## VIDEO TECHNICAL BULLETIN

<b><u>MODELS</u></b>	<b>VCM26HM</b>	<b>VCM271HM</b>	<b>VCM27HM</b>	<b>VCMH67HM</b>
	<b>VCMH68HM</b>

Reference TB-T9905070

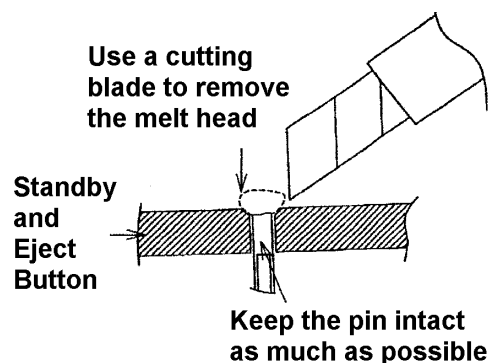
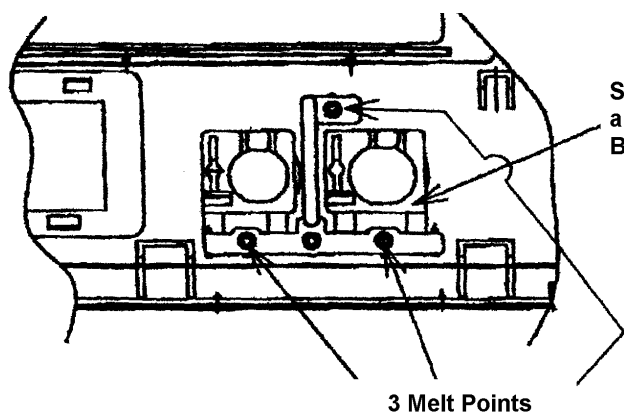
**SYMPTOM** Failure of the front panel buttons.

**CAUSE** Excess travel of the button, causing the hinge to fracture.

**ACTION** Replace the broken button assembly and add the holder as shown in the following diagrams.

Note that there are two types of holder for different models.

Holder one  
VCM26HM VCMH67HM

Holder two  
VCM271HM VCM27HM VCMH68HM
